STAFF REPORT WEST ALLIS PLAN COMMISSION WEDNESDAY, October 24, 2018 6:00 PM

7. Signage Plan Appeal for Ironworkers Local 8 Headquarters located at 12034 W. Adler Ln., submitted by Zach Wenger d/b/a Lemberg Electric. (Tax Key No. 413-9994-018)

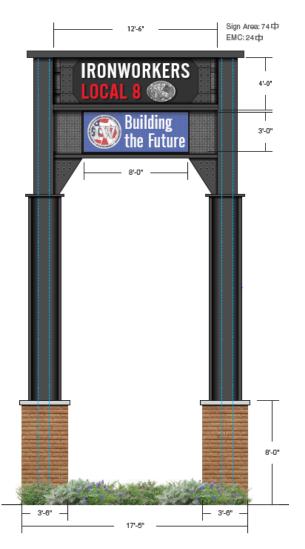
- This is currently a non-conforming 160sf sign being replaced by a non-conforming 160sf sign.
- The existing sign is useable and may remain in place until altered, removed or discontinued in accordance with 13.21(4).

- The existing non-conforming sign provides for the expression of both commercial and non-commercial speech and for the for the identification and advertising needs of businesses
- The proposed variance will not preserve the beauty and the unique character of the City by aesthetically complementing the development, which the sign identifies.
- Nor promote a healthy and properly designed business environment.
